CITY OF YPSILANTI
Historic District Commission
Regular Meeting Agenda

Tuesday, March 22, 2016
7:00 p.m.

HDC Work Permit Staff Review

405 MAPLE PORCH
YPSILANTI, MI 48198
COMMUNITY BUILDERS LC
734 216 6575
3.14.16 SH. 10F3

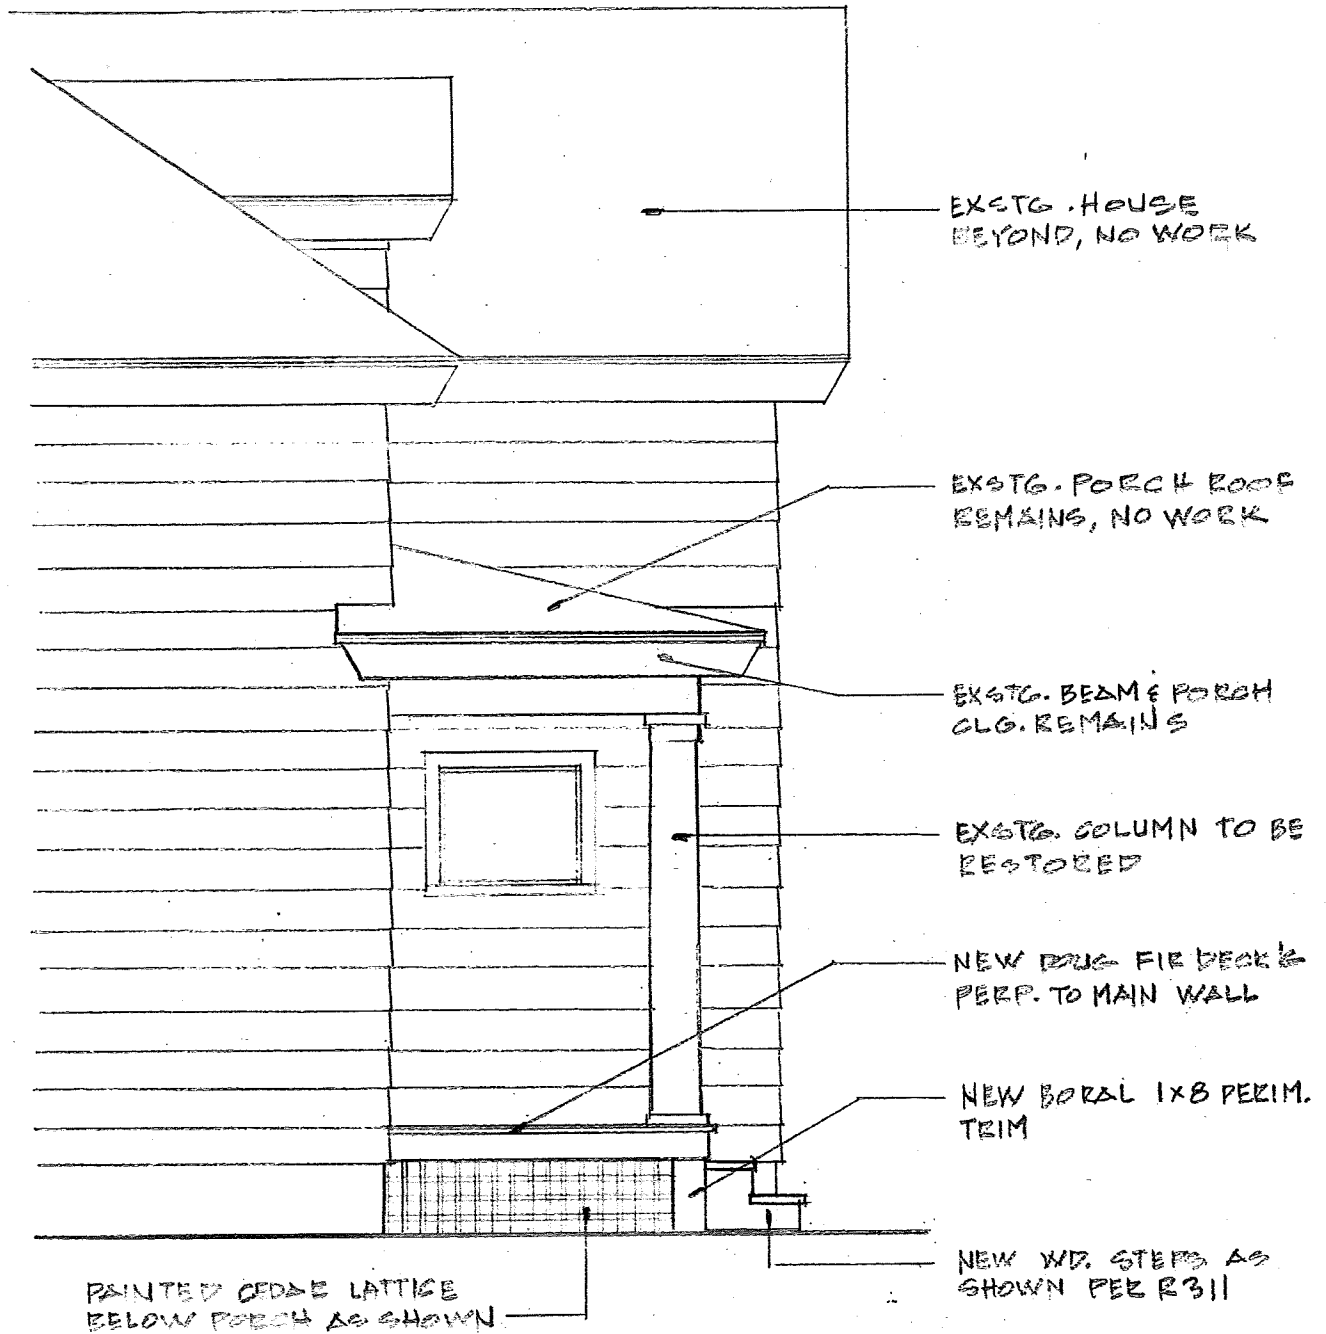
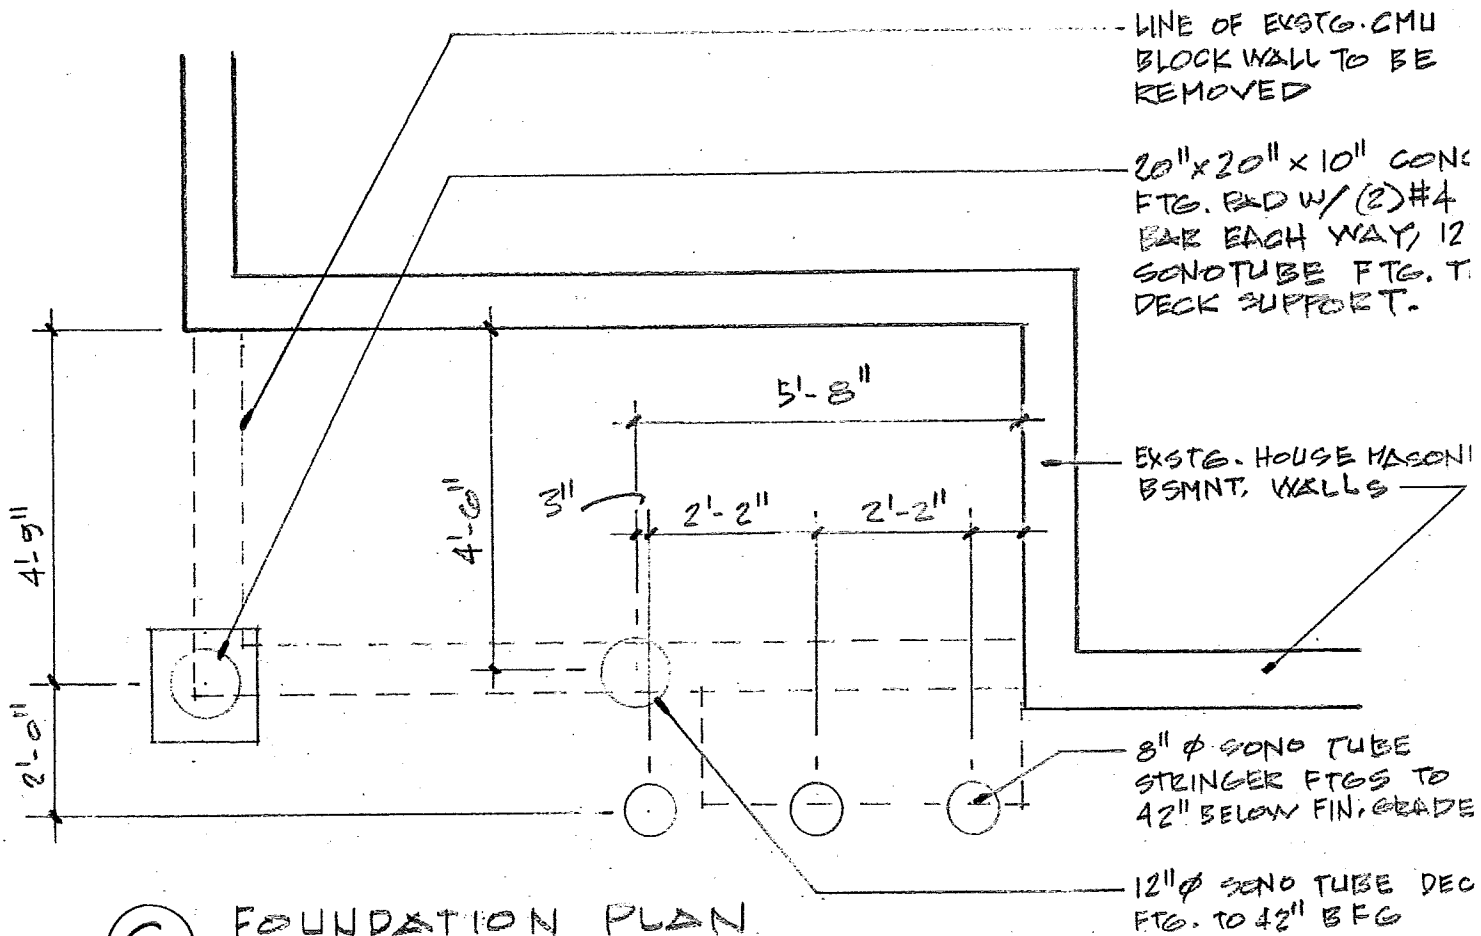
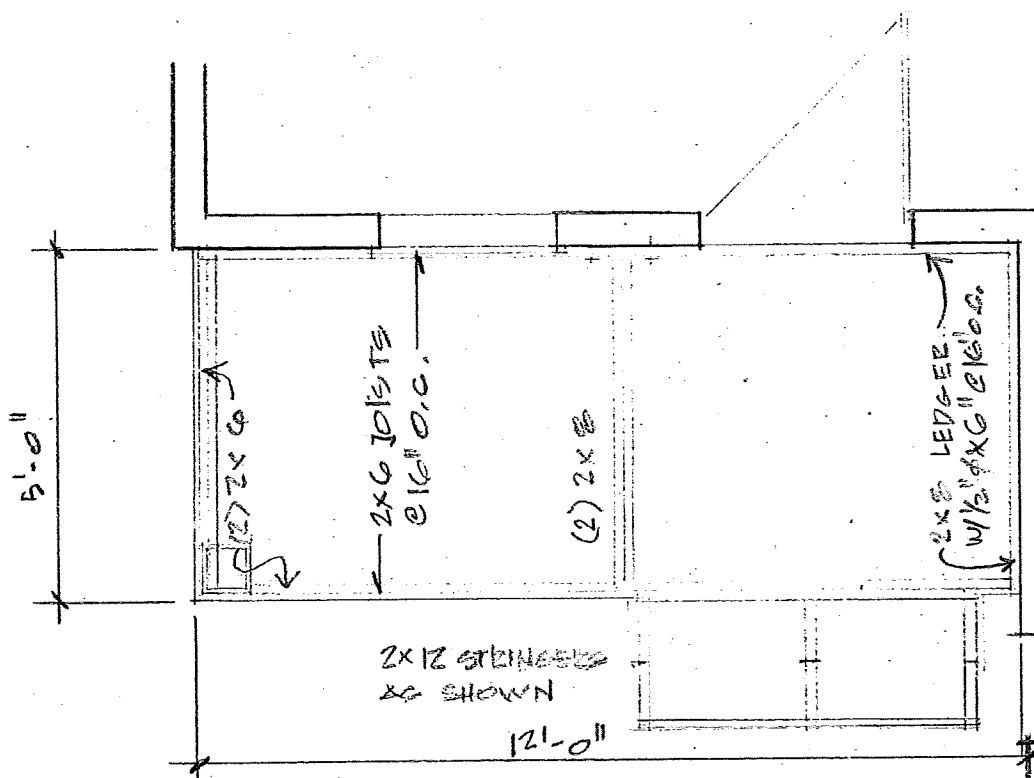
NEW WD. STEPS AS
SHOWN PER R311
AND HDC GUIDELINES

Proposed Site Plan

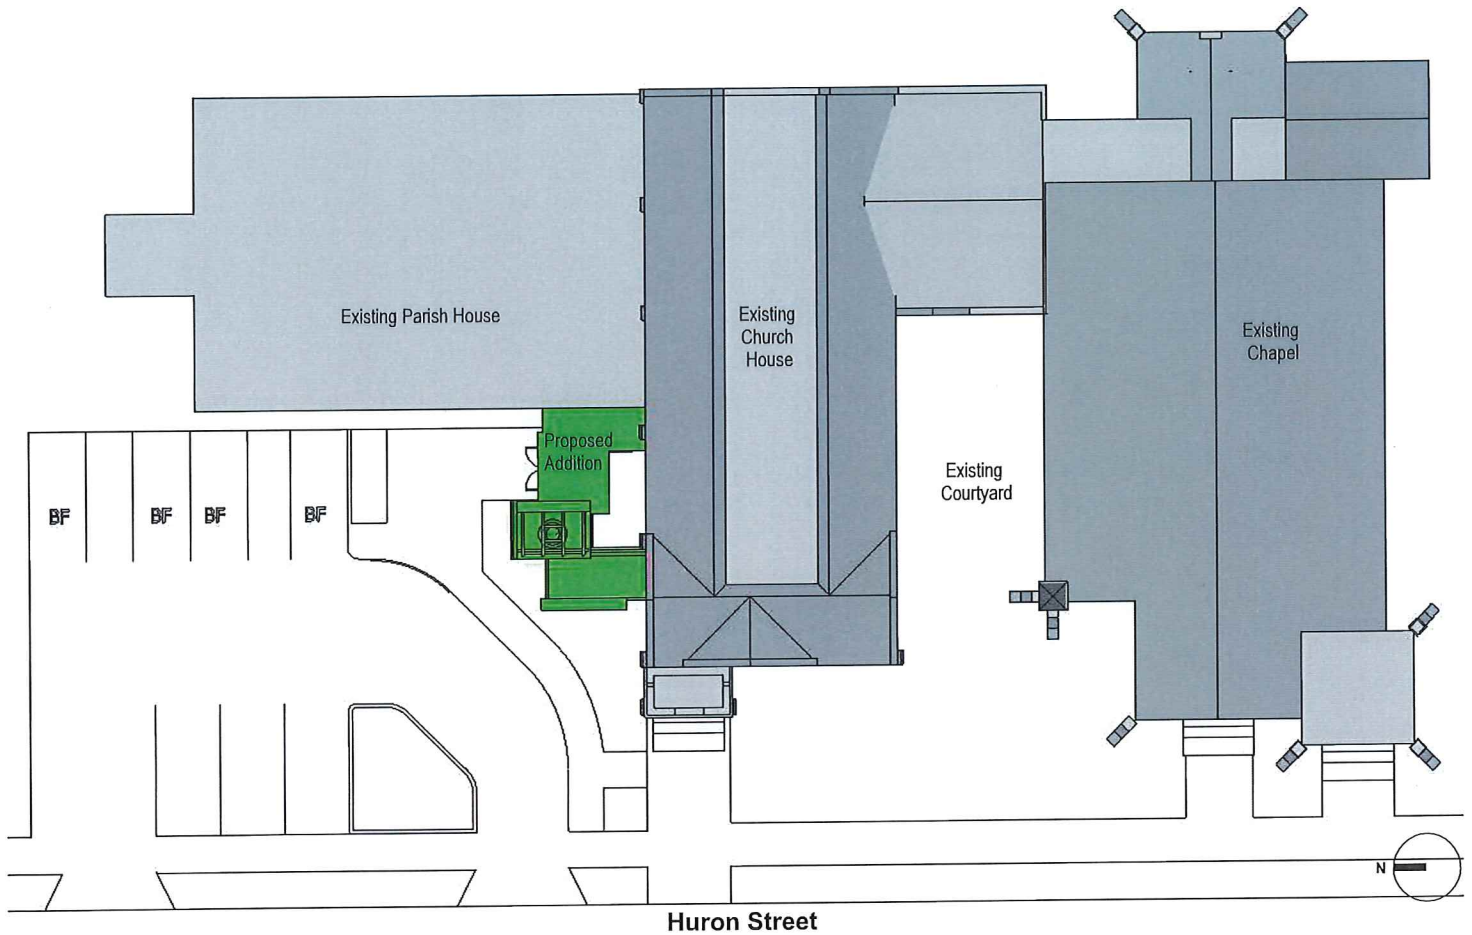
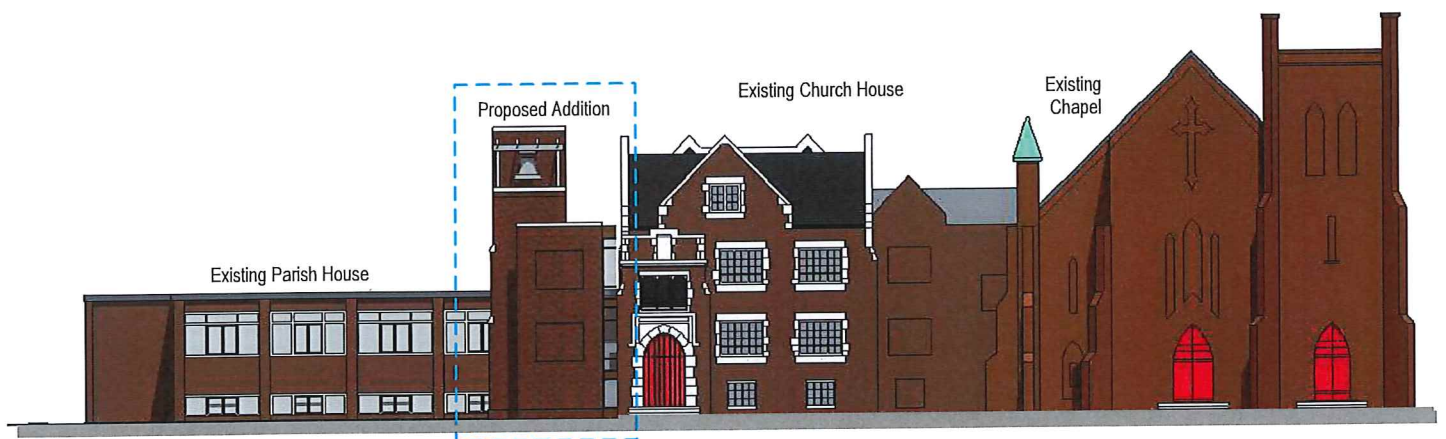
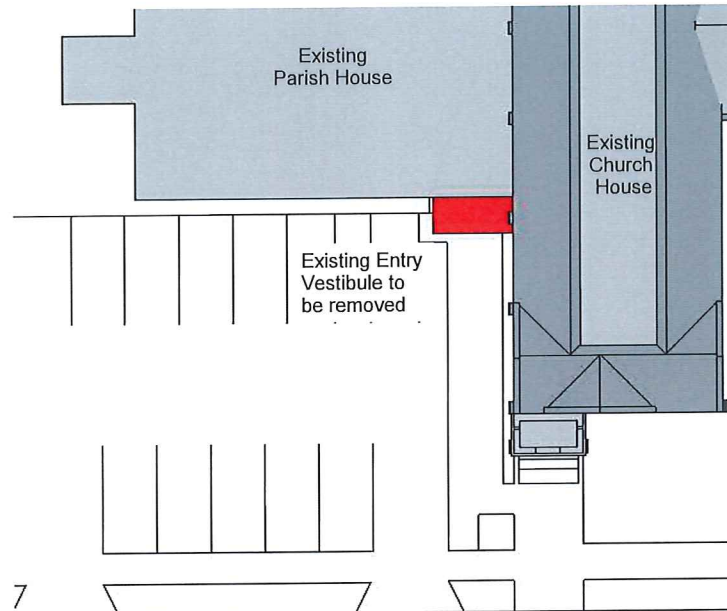
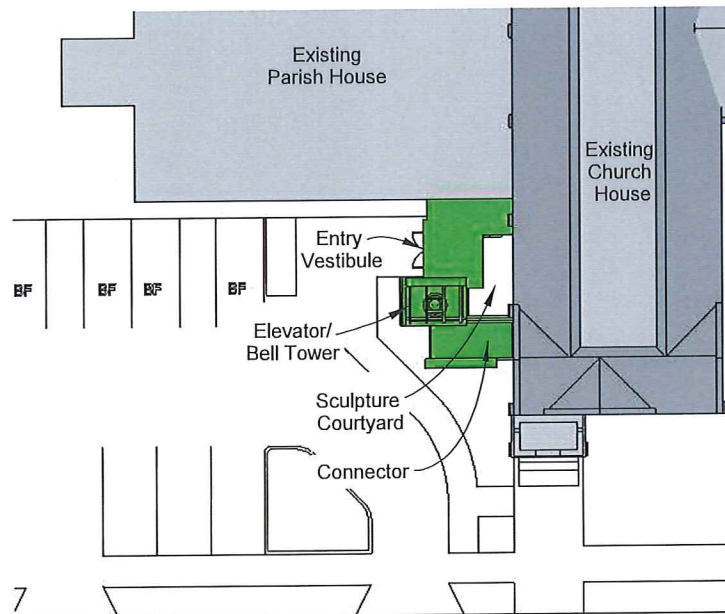
The proposal is for an elevator addition to St. Luke's Episcopal Church. There are three existing parts of the church: the original 1858 Chapel, the 1929 Church House, and the 1956 Parish House. Currently a series of unpopular chair lifts are used to make the first and second floors of the Church House and Parish House accessible, but the Church House has an auditorium on the third floor which currently can only be reached via stairs.
